Access Compliance Report

Public Rights-of-Way

(Curb Ramps)

| Intersection ID: 14797 | Main Street: LYNDHURST_AV | Cross Street: MAGNOLIA_AV | Location: E |

| ADA ID: 550521EDD208 | Ramp Type: Directional1 | Initial Pass/Fail: Fail | Overall Compliance: No |

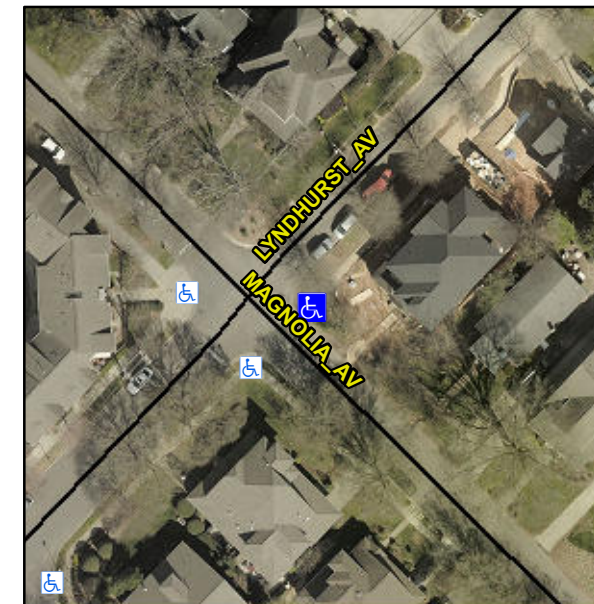
R304.2.2, R304.5.3

| Compliance | Description | Data | Compliance | Description | Data |
|------------|-----------------------|-------|------------|-----------------------------|------|
| No | Ramp Slope (%) | 10.0 | N/A | Grade Break XSlope (%) | 0.0 |
| No | Ramp XSlope (%) | 2.3 | | | |

Remove & Replace Entire Ramp.
